FCC Class II PC request letter
DP AUDIO VIDEO LLC

Attn: OET Dept.
Ref: FCC Class II Permissive change for FCC ID:2AVRVKRC101
Applicant: DP AUDIO VIDEO LLC

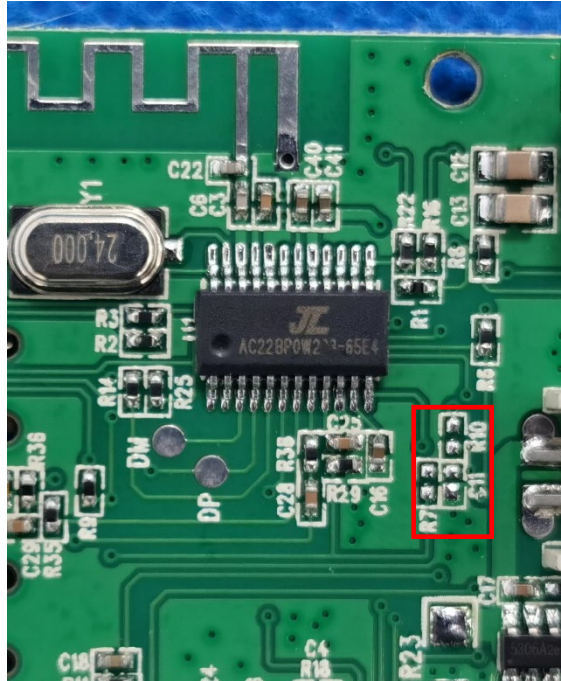
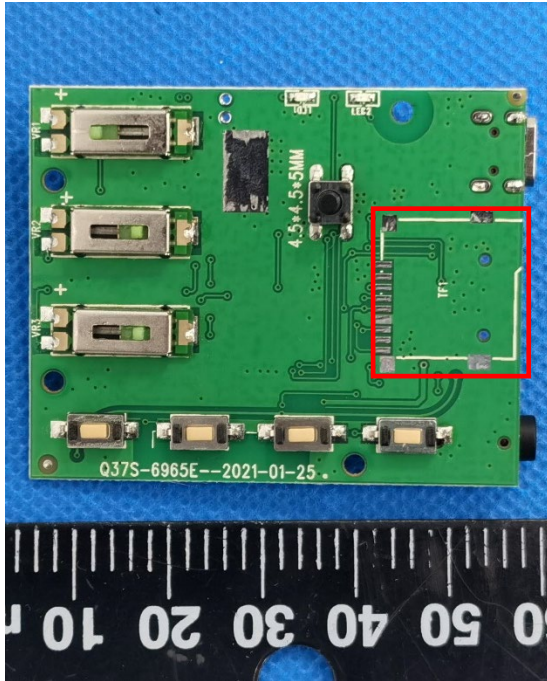
Changes : 1. The new product has removed the TF booth and TF circuit.

Remark: Based on the changes in the product, It affects Conducted emissions and Radiated Emissions.
